# Errata to MPC8560 PowerQUICC III Integrated Communications Processor Reference Manual, Rev. 1

This errata describes corrections to the *MPC8560 PowerQUICC III Integrated Communications Processor Reference Manual, Rev. 1*. For convenience, the section number and page number of the errata item in the reference manual are provided. Items in bold are new since the last revision of this document.

Document Number: MPC8560RMAD

Rev. 1.4

**Figure 12-26. GPCM Relaxed Timing Read (XACS = 0, ACS = 1x, SCY = 1, EHTR = 0, TRLX = 1**

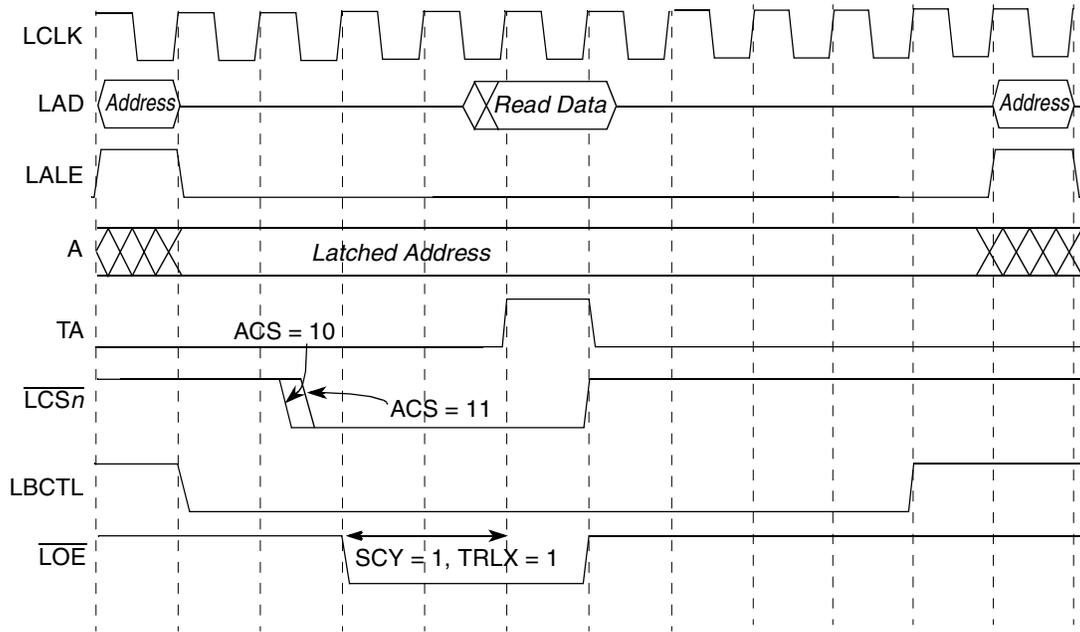
12.4.2.2.3, 12-44

Change the title of Figure 12-26 to “GPCM Relaxed Timing Read (XACS = 0, ACS = 1x, SCY = 1, EHTR = 0, TRLX = 1,” and replace the figure with the following:
